GENERAL PLAN AND ELEVATION
BR. 1 001 279

REHABILITATION OF BRIDGES
1 & 1A ON RISING SUN LANE
OVER BRANDYWINE CREEK

ADDENDUM NO. 2	B.K.B. II/05/08
MODIFIED NOTE

EXISTING TRUSS NOT SHOWN FOR CLARITY.

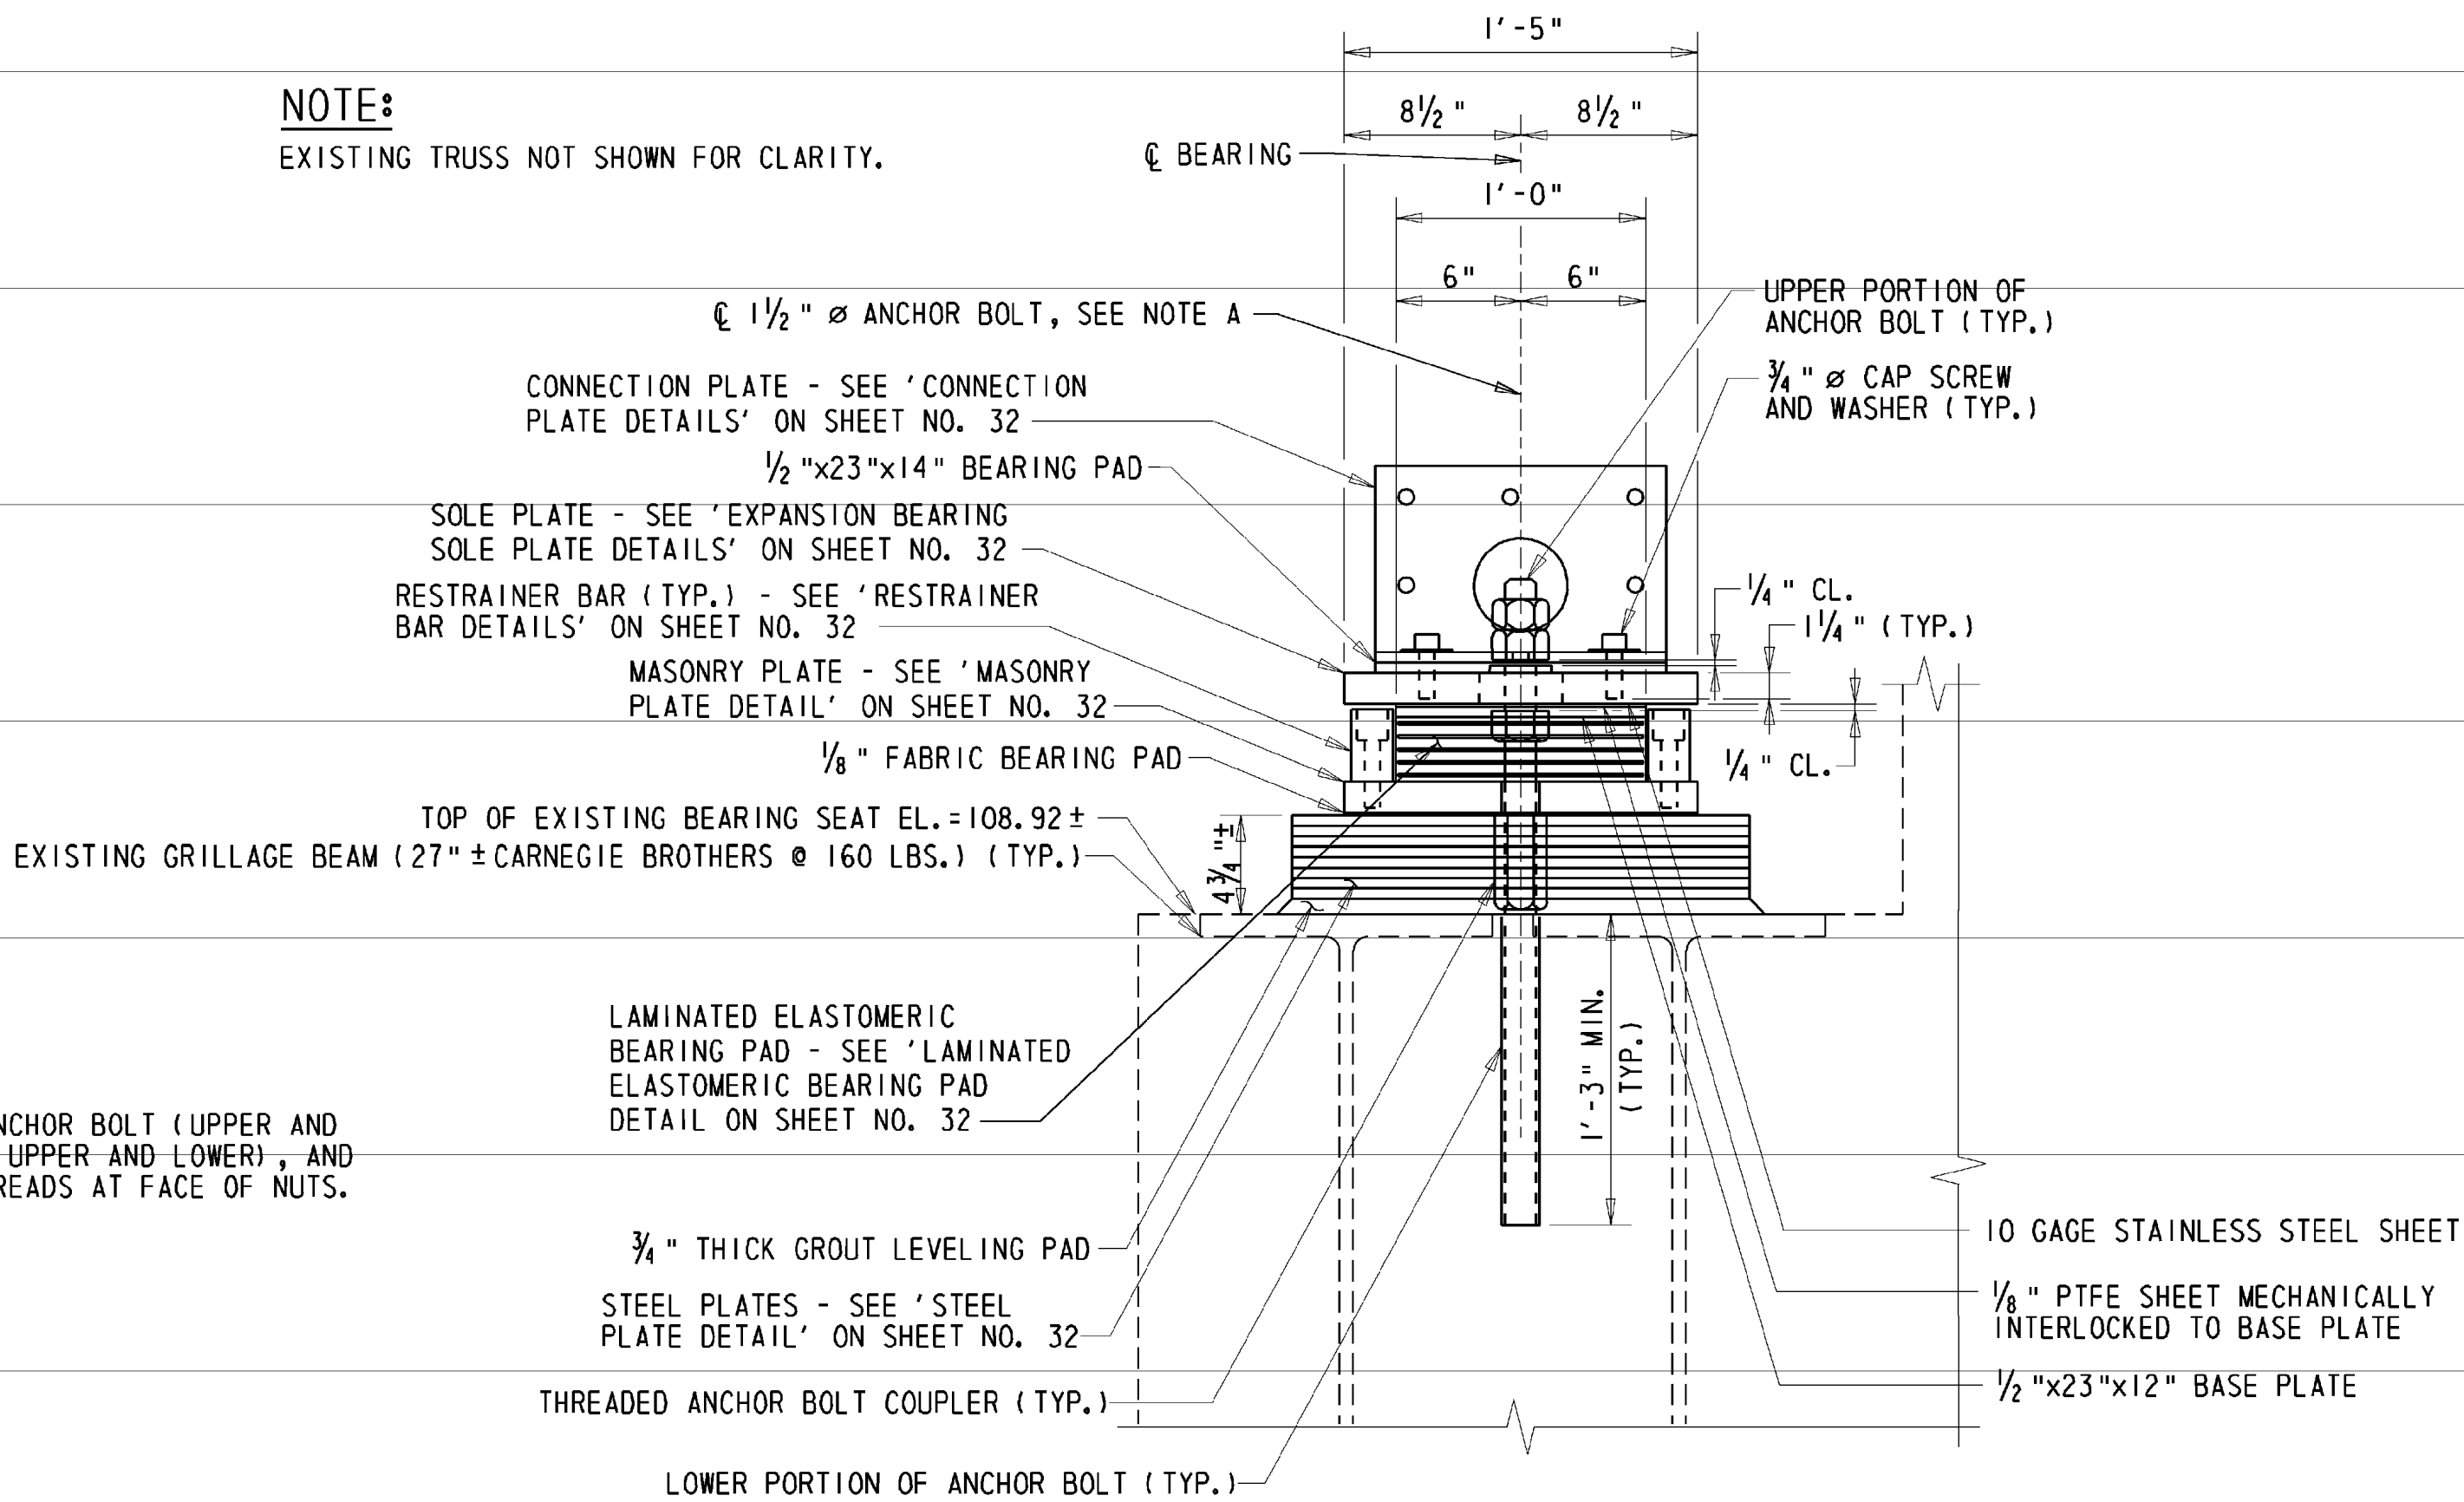
- CONTRACTOR SHALL REMOVE EXISTING COUNTERSUNK AND CHIPPED RIVETS WITHIN GUSSET PLATE AND PIN PLATE SURROUNDING EXISTING 4 1/2" ± DIAMETER PIN. DIMENSIONS FOR CONNECTION PLATE AND LOCATIONS OF 1/8" ∅ HOLES FOR 3/4" ∅ HIGH STRENGTH TENSION CONTROL BOLTS ARE APPROXIMATE AND BASED ON UTILIZING THE LOCATION OF THE EXISTING COUNTERSUNK AND CHIPPED RIVET HOLES. THE LOCATION OF THE EXISTING COUNTERSUNK AND CHIPPED RIVETS SHALL BE VERIFIED IN THE FIELD PRIOR TO ORDERING OR FABRICATING MATERIALS.

CONTRACT	COUNTY	F.A.P. NO.	SHEET NO.	TOTAL SHTS.
2I-074-0I	NEW CASTLE	EBHN-N279(II)	3I	83

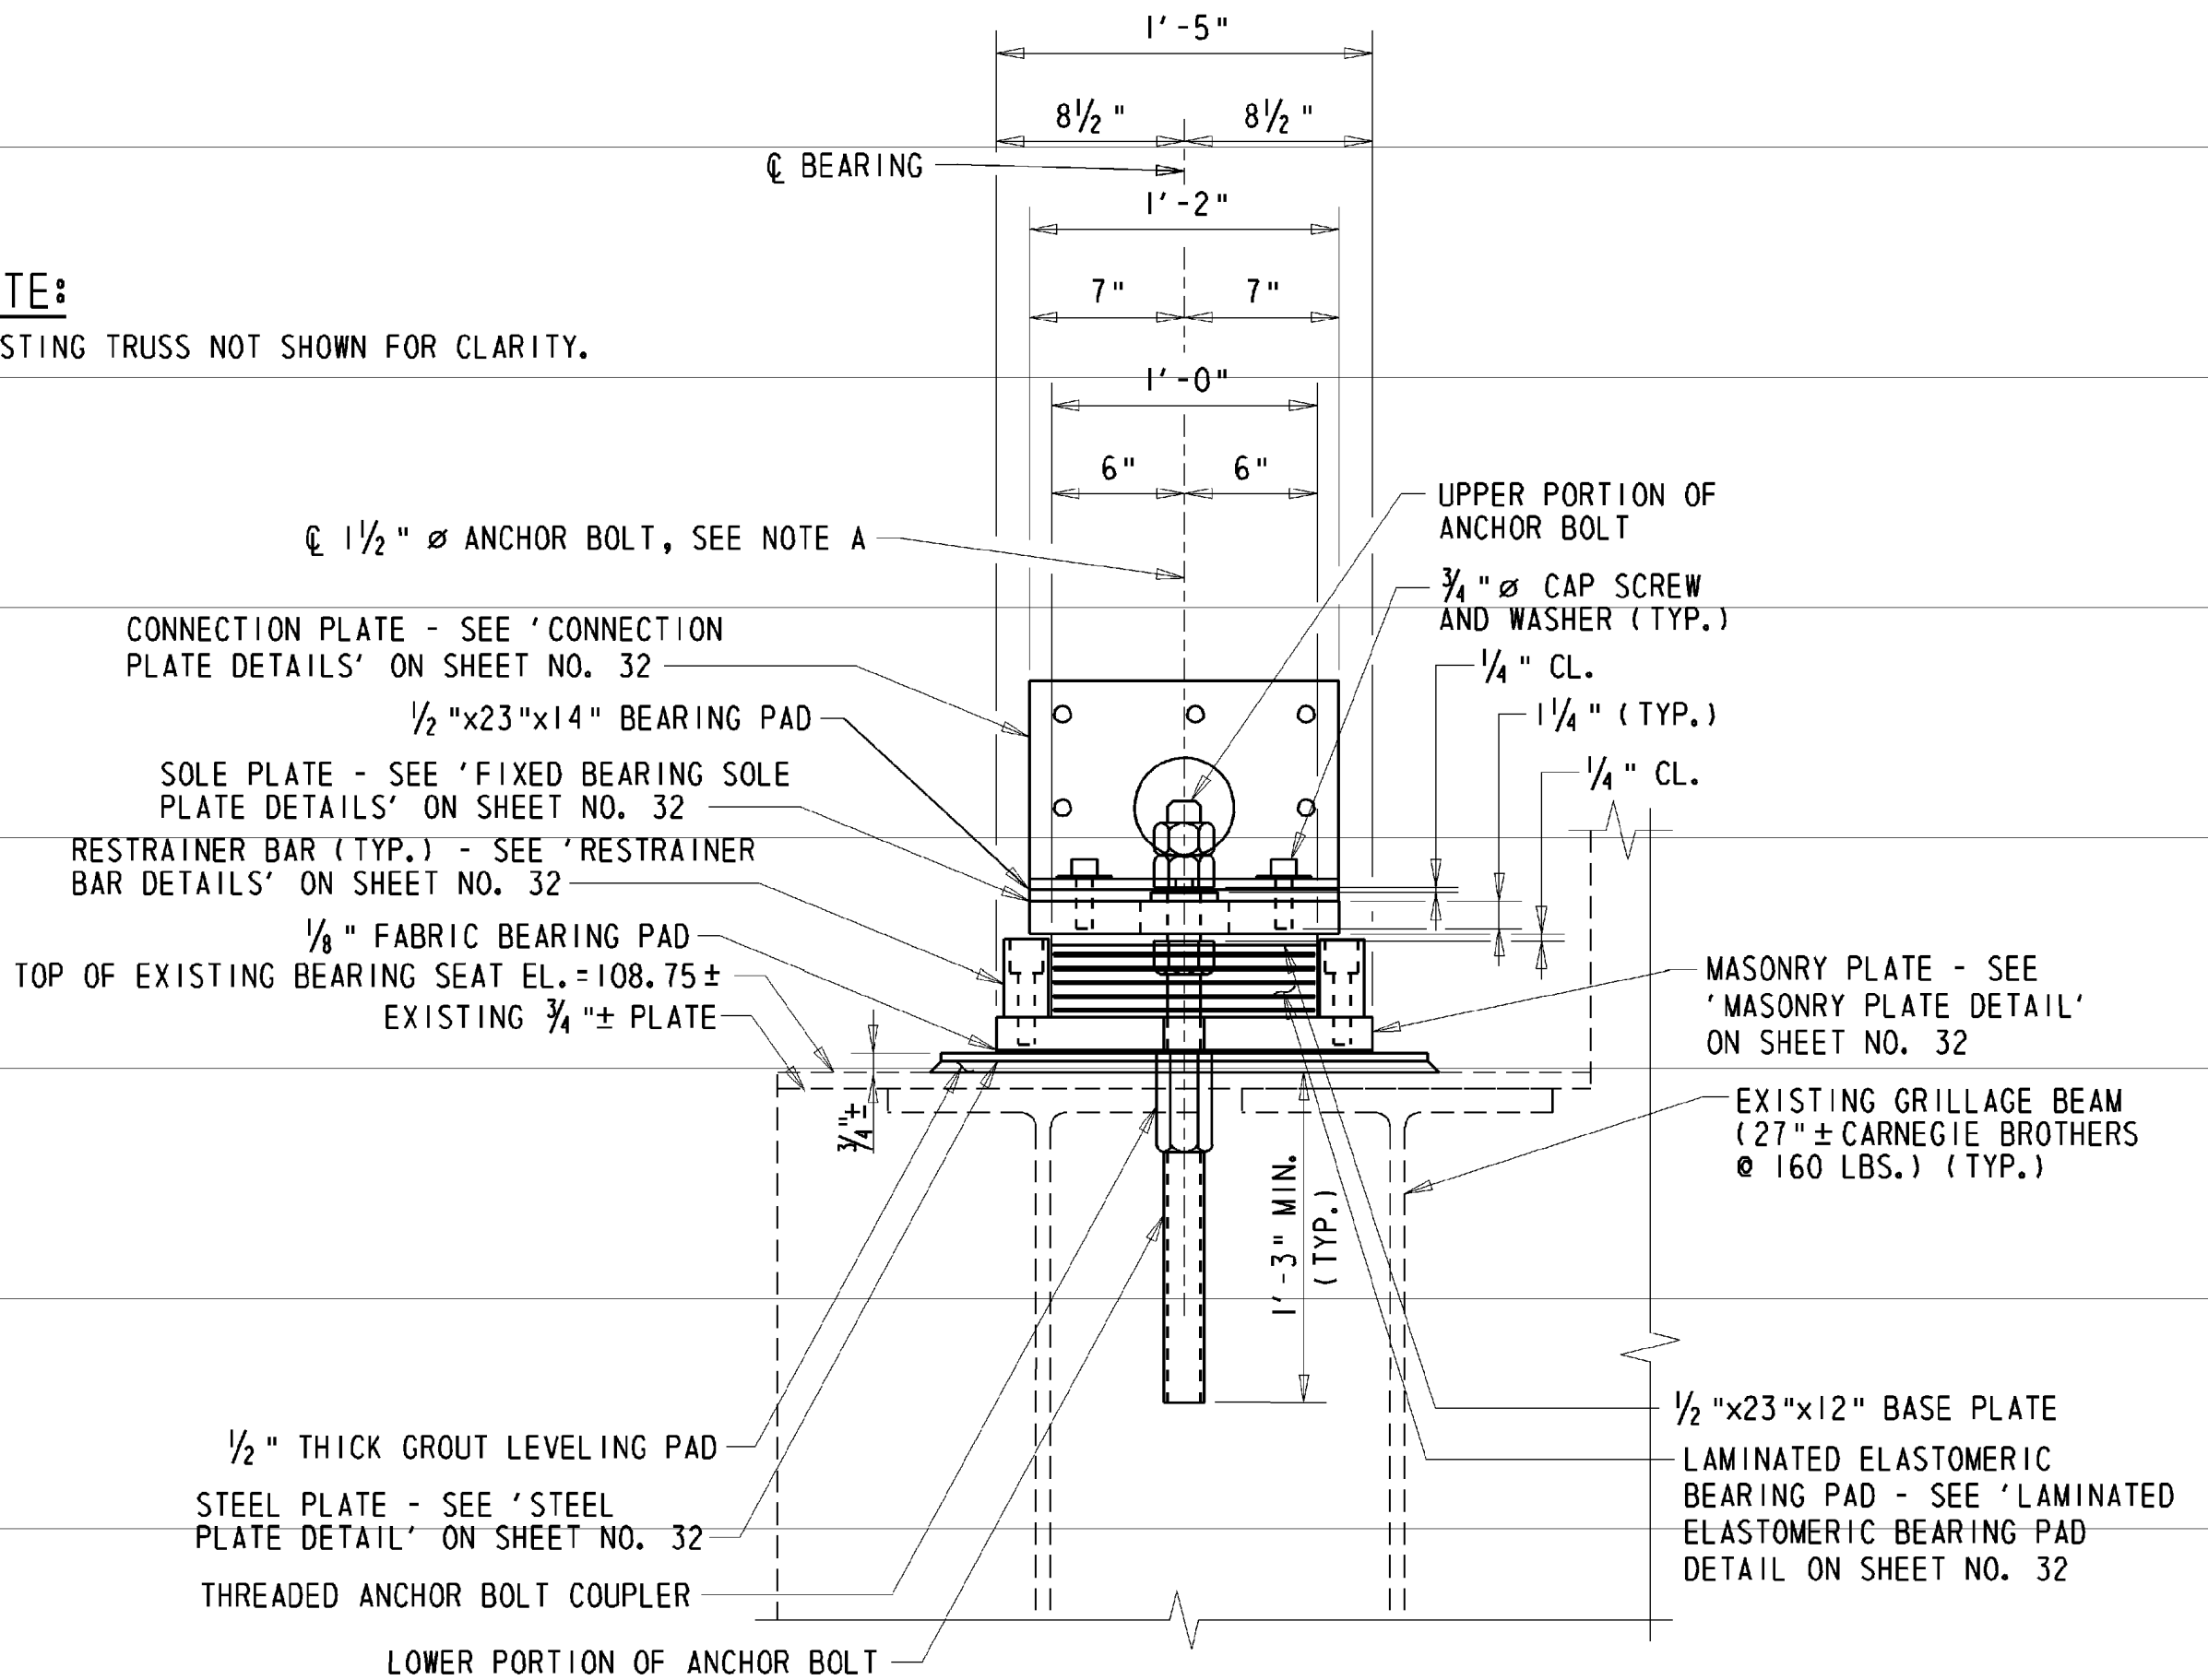
ADDENDUM NO. 2	B.K.B. II/05/08
MODIFIED NOTE

- CONTRACTOR SHALL REMOVE EXISTING COUNTERSUNK AND CHIPPED RIVETS WITHIN GUSSET PLATE AND PIN PLATE SURROUNDING EXISTING 4 1/2" ± DIAMETER PIN. DIMENSIONS FOR CONNECTION PLATE AND LOCATIONS OF 1/4" ∅ HOLES FOR 3/4" ∅ HIGH STRENGTH TENSION CONTROL BOLTS ARE APPROXIMATE AND BASED ON UTILIZING THE LOCATION OF THE EXISTING COUNTERSUNK AND CHIPPED RIVET HOLES. THE LOCATION OF THE EXISTING COUNTERSUNK AND CHIPPED RIVETS SHALL BE VERIFIED IN THE FIELD PRIOR TO ORDERING OR FABRICATING MATERIALS.
